UNITED STATES PATENT AND TRADEMARK OFFICE

APPLICATION NO.	FILING DATE	FIRST NAMED INVENTOR	ATTORNEY DOCKET NO.	CONFIRMATION NO.
09/857,348	07/24/2001	Fredrik Persson	66477-012-5	3135

Office Action Summary

DETAILED ACTION

FIG. (a)

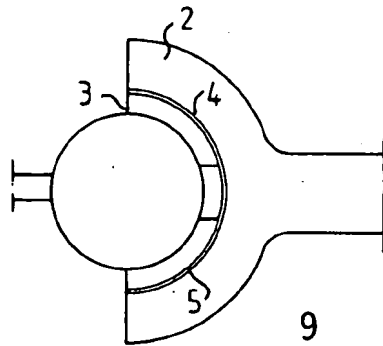
- Figure 4 as described in the specification is missing from the drawings. The two separate images associated with the labels "FIG.(a)" and "FIG.(b)" should each be separately labeled as --FIG.4a-- and --FIG.4b--, respectively.
- The numeral "9" as shown in newly amended FIG.(a) appears to be a typographical error and should be deleted.
- Figure 5 should be labeled as "prior art" since only that which is old and known is shown.

FIG. 5

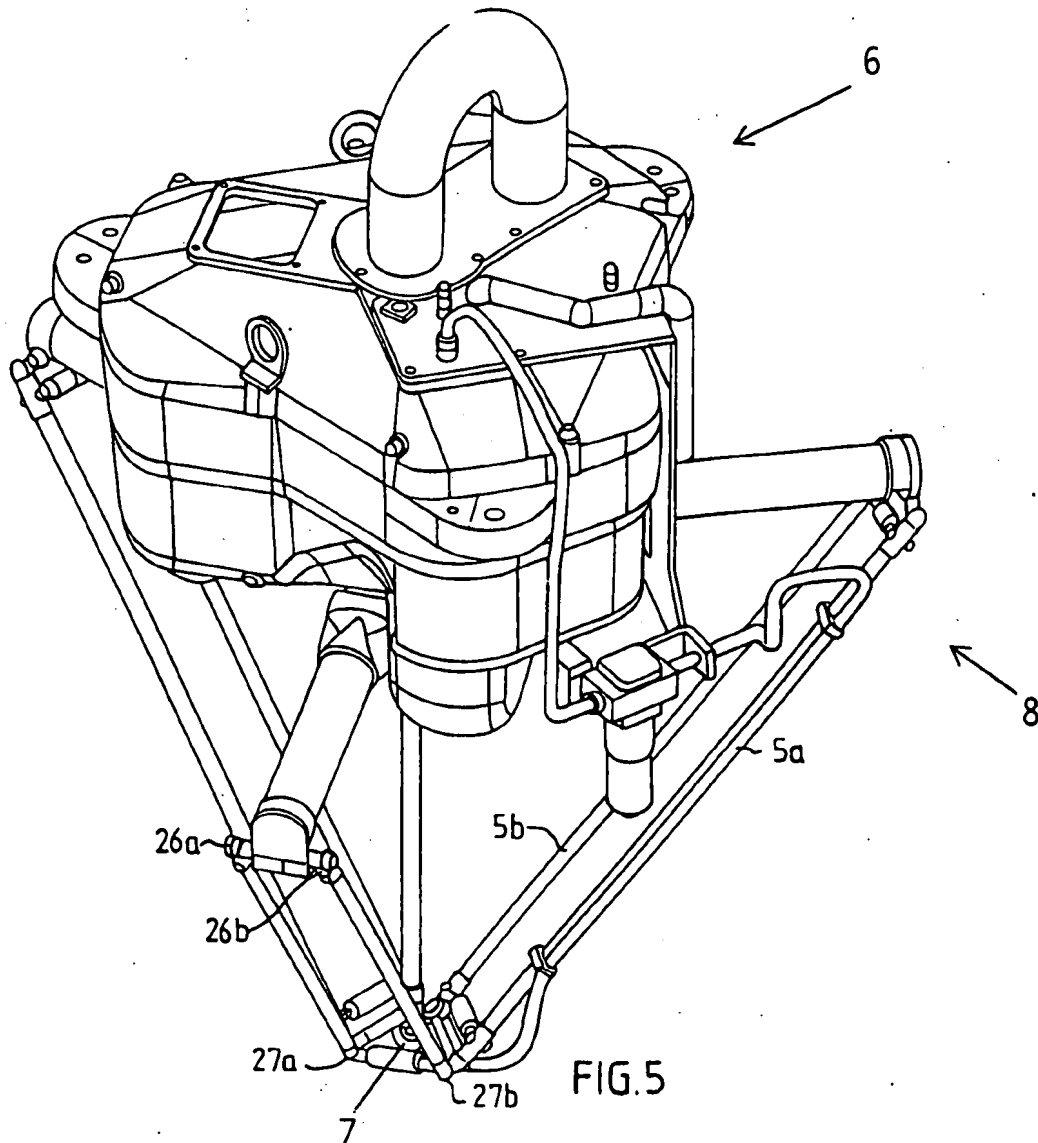
The applicant argues that figure 5 need not be labeled as prior art since it includes subject matter that was not known prior to applicant's invention. This is not persuasive. First, applicant has failed to identify any specific elements in figure 5 that are not prior art. Second, applicant's specification as originally filed (p.1, ll.10-15) stated that figure 5 was prior art. Once an

applicant admits that a figure is prior art such admission cannot be retracted. Also note that applicant's figure 5 as filed on July 11, 2006 clearly labeled figure 5 as prior art.
